TRAFFIC CONTROL PLAN FOR THE ROCKINGHAM BRF 0126(12) PROJECT

SHEET S1-SIGNAL PLAN
SHEET S2-TRAFFIC SIGN LAY-OUT
SHEET S3-TRAFFIC SIGN LAY-OUT

PREPARED
BY
COLD RIVER BRIDGES, LLC

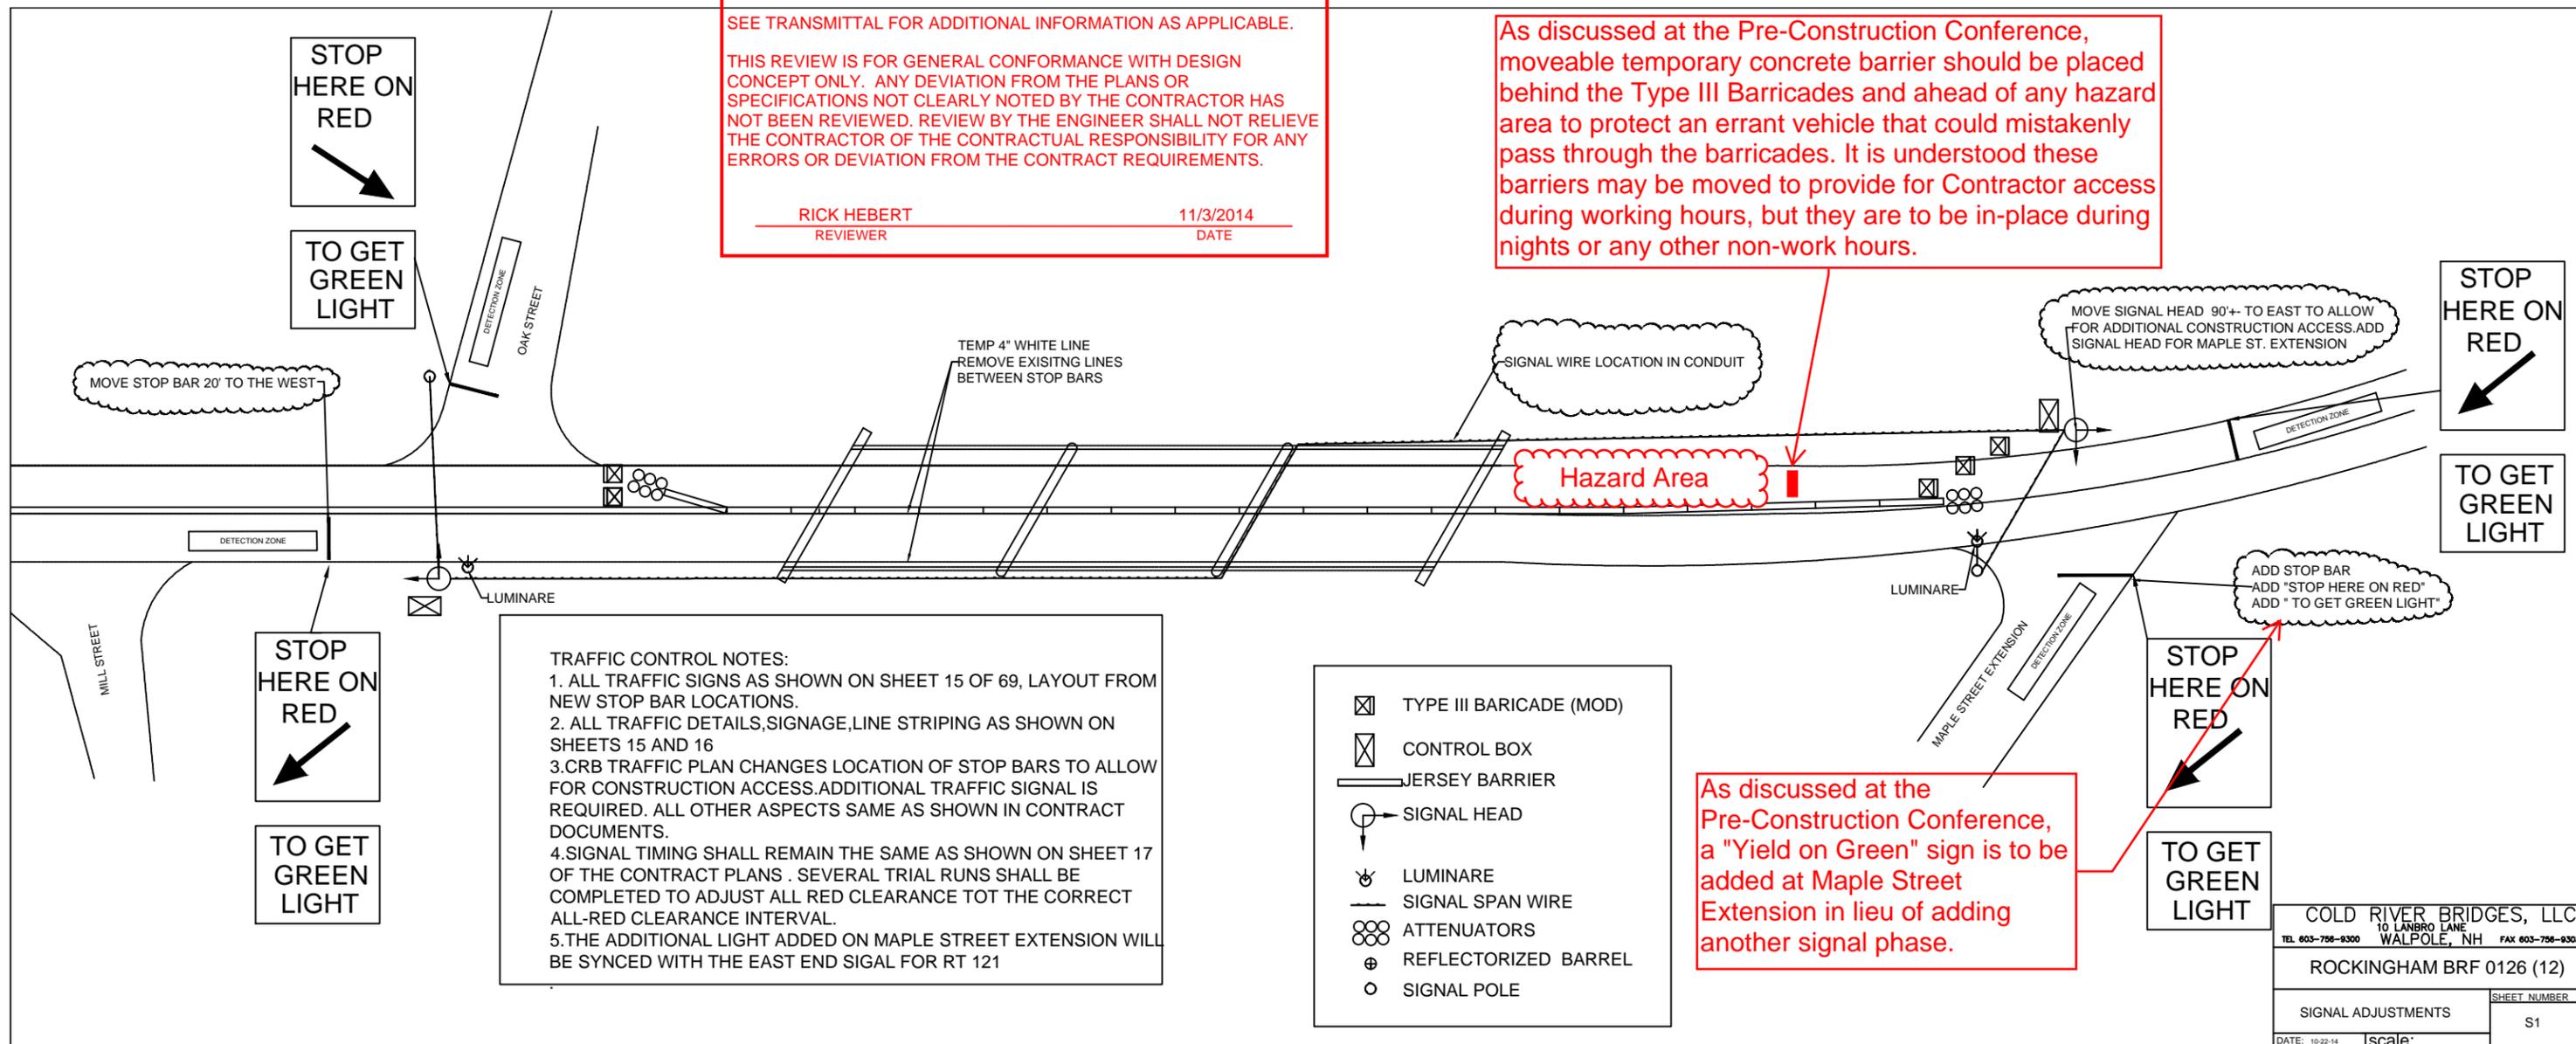
As discussed at the Pre-Construction Conference, moveable temporary concrete barrier should be placed behind the Type III Barricades and ahead of any hazard area to protect an errant vehicle that could mistakenly pass through the barricades. It is understood these barriers may be moved to provide for Contractor access during working hours, but they are to be in-place during nights or any other non-work hours.

COLD RIVER BRIDGES, LLC 10 LANBRO LANE WALPOLE, NH	
TEL 603-756-9300 FAX 603-756-9303	
ROCKINGHAM BRF 0126 (12)	
SIGNAL ADJUSTMENTS	SHEET NUMBER
DATE: 10-22-14	S2
scale:

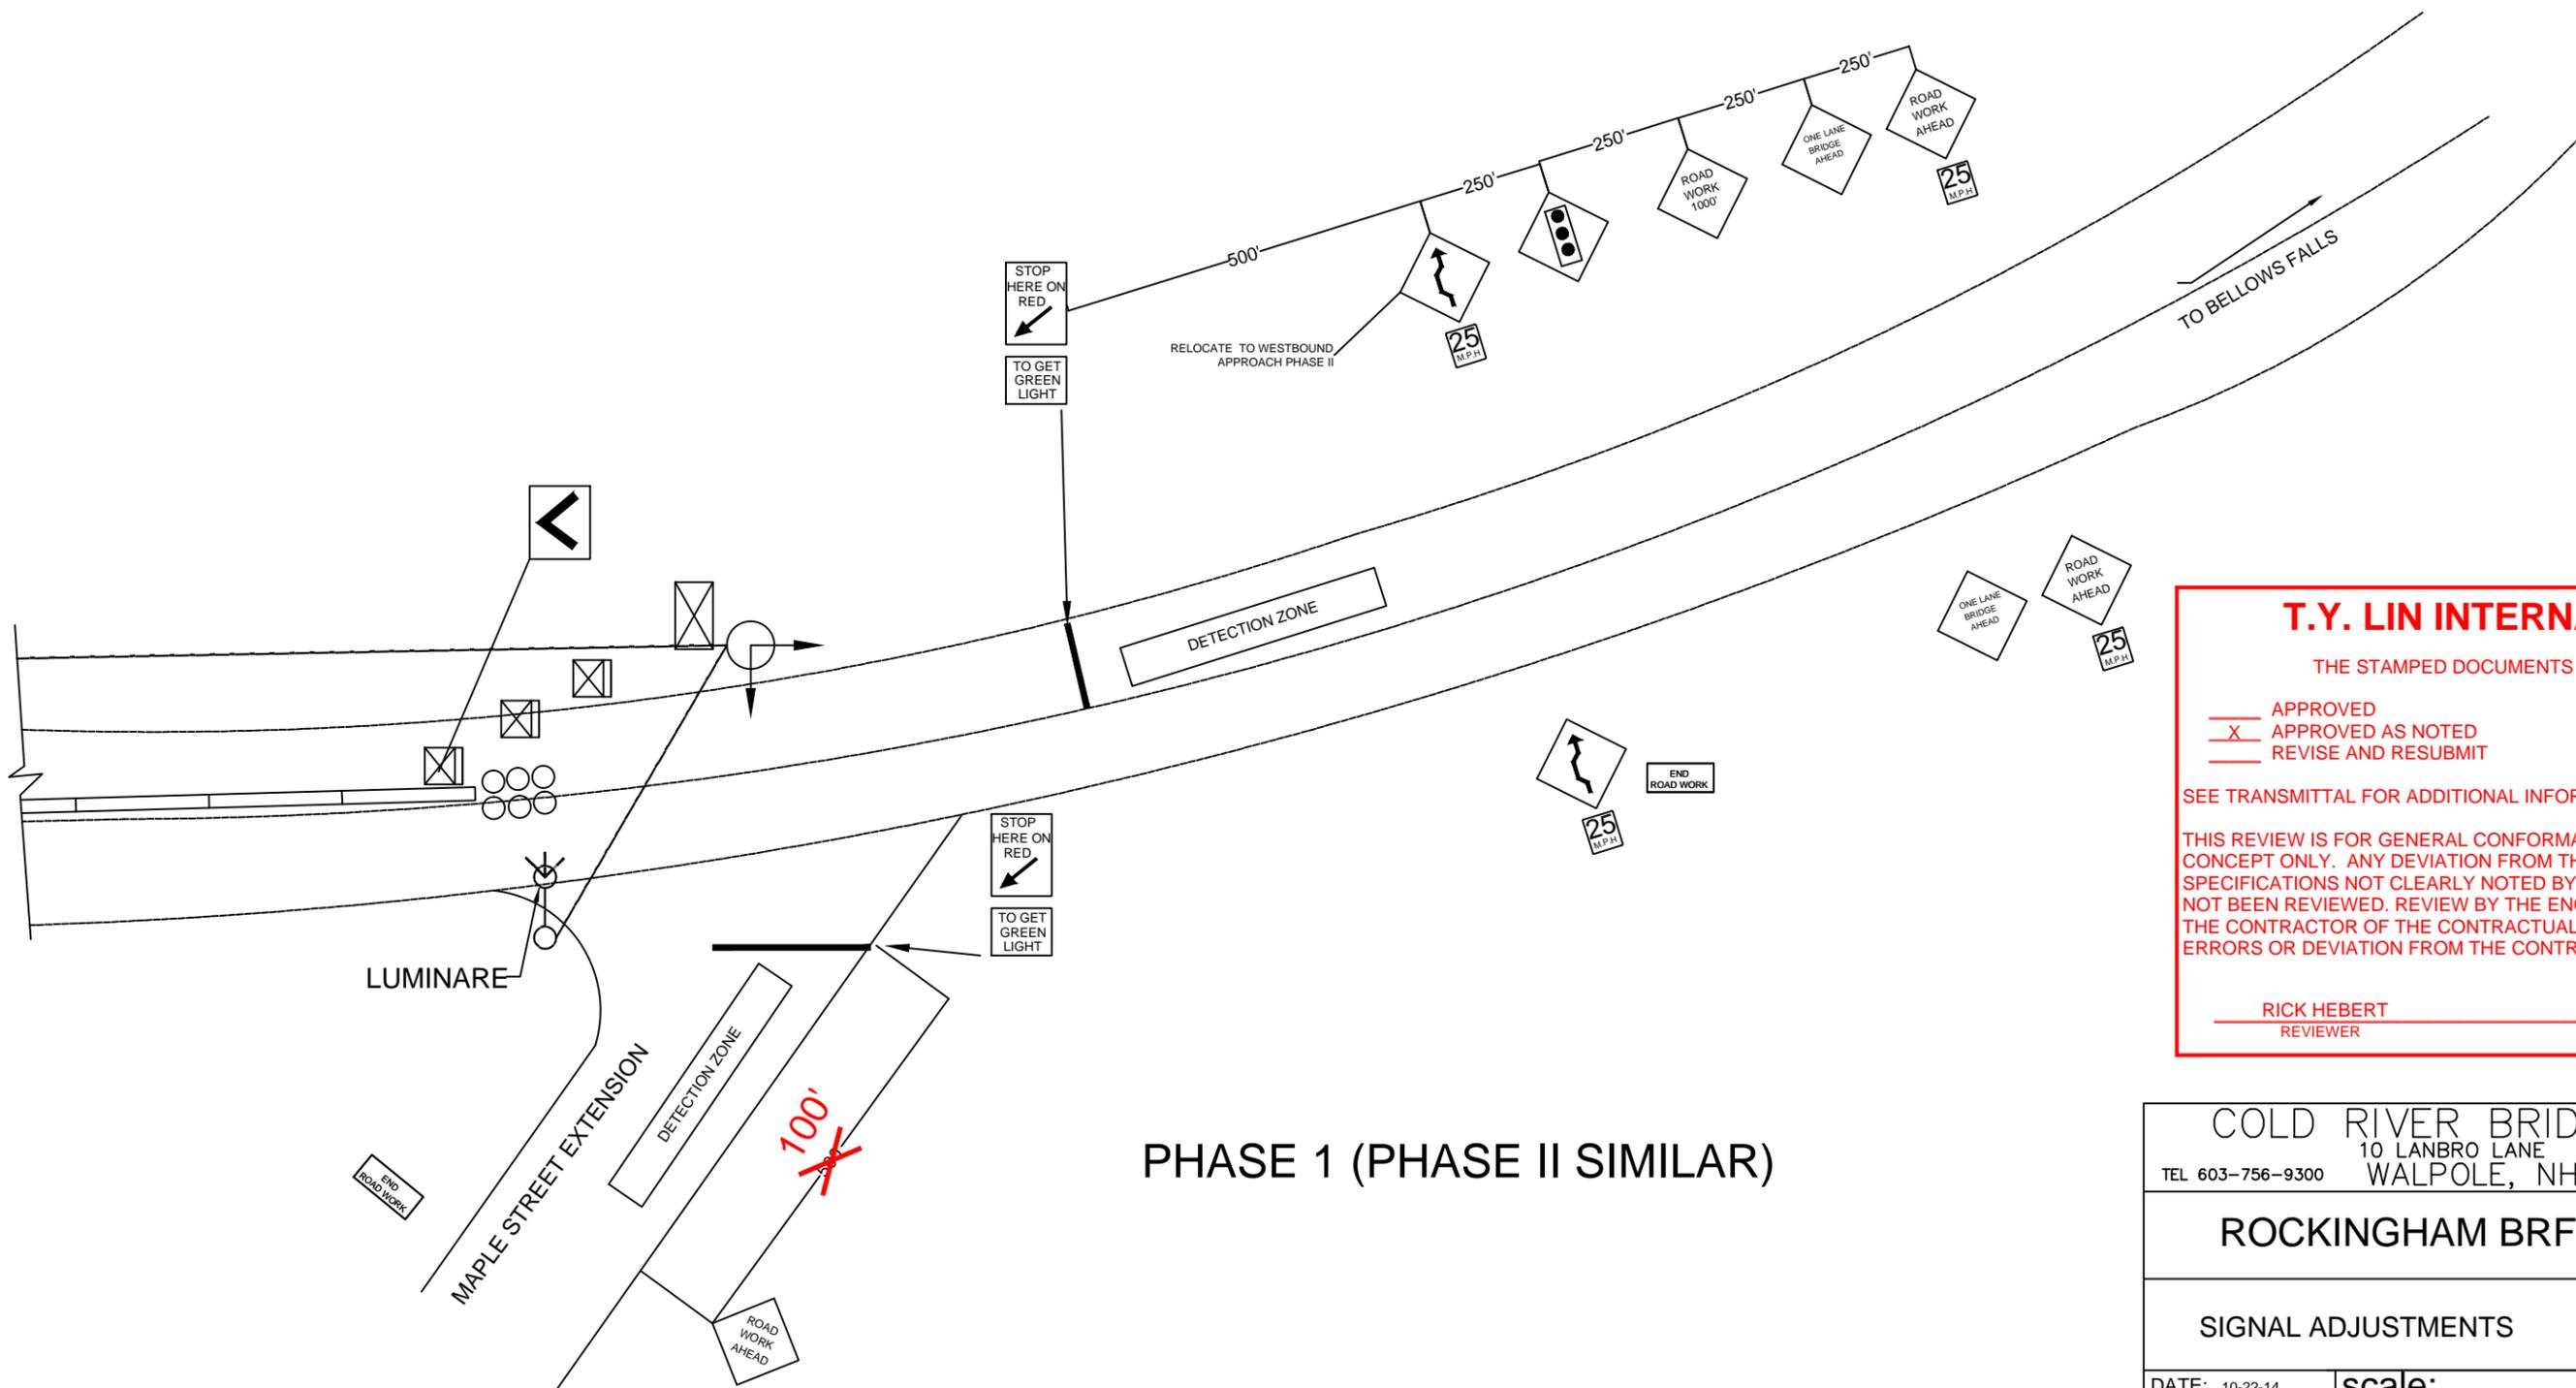
As discussed at the Pre-Construction Conference, a "Yield on Green" sign is to be added at Maple Street Extension in lieu of adding another signal phase.
